REMARKS

Appl. No. 10/041,597
Amdt. dated October 6, 2004
Reply to Office Action of June 4, 2004
Annotated Sheets Showing Changes

FIG. 8

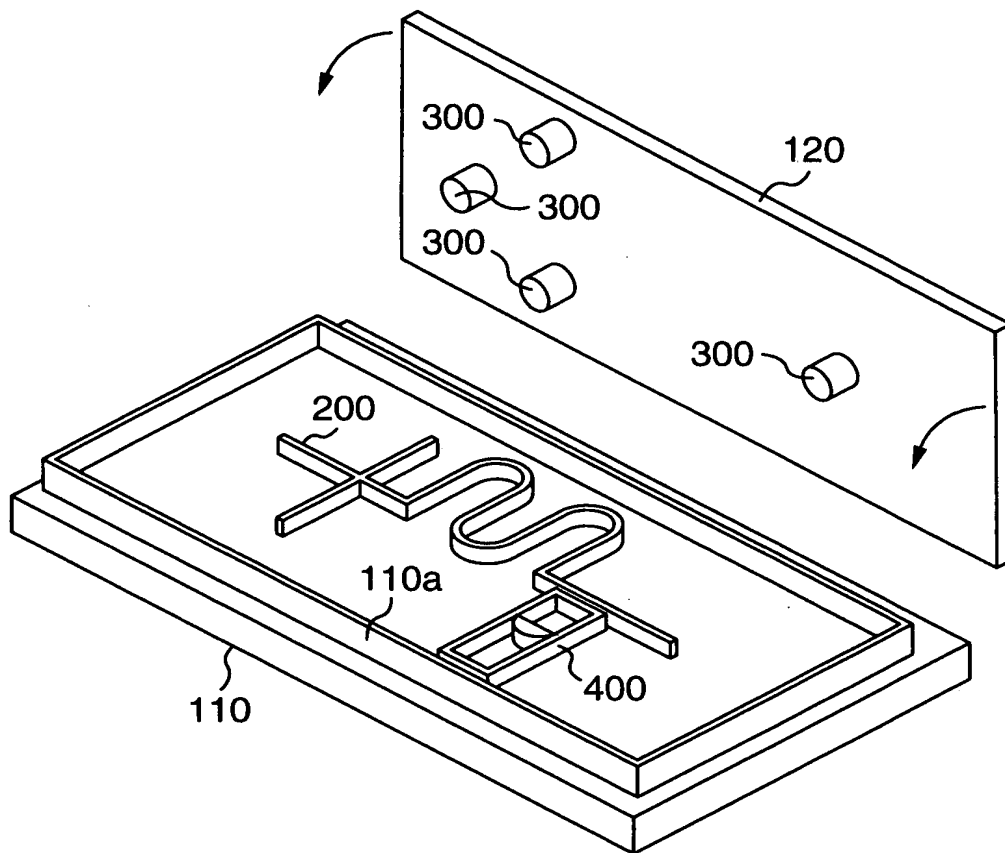
The drawings have also been objected to as failing to comply with 37 C.F.R. §1.84(p)(5) because reference signs 1200, 1900, 2000 and 2100, as shown in FIG. 8, were not described in the specification. In response thereto, the specification has

been reviewed, and FIG. 8 has been revised to delete those reference signs, which are not material to the patentability of claims 1-11 as pending in the application, in order to place the application in condition for allowance.

FIG. 3

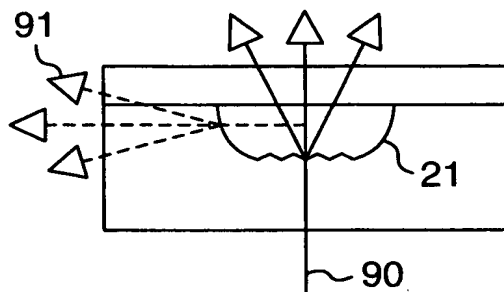
The drawings have been objected to because FIG. 3 is not designated by a legend such as "Prior Art." However, this objection is incorrect. FIG. 3 is not believed to constitute "prior art" as that term is defined by either 35 U.S.C. §102 or 35 U.S.C. §103. Rather, FIG. 3 is simply an abstract representation of the art prepared by Applicants in an effort to illustrate Applicants' discovery of problems plagued in the art; this discovery is itself, together with Applicants' abstraction of the art represented by FIG. 3, part of Applicants' invention. FIG. 3 is therefore, Applicants' work products and Applicants' effort to describe his invention in terms of both the problems which have plagued in the art and which Applicants have addressed with the inventions defined by the claims. In view of these explanations, Applicants again trust that the objection will be withdrawn. Nevertheless, for purposes of expedition, FIG. 3 has been labeled as "Related Art" in order to place the application in condition for allowance.

RELATED ART
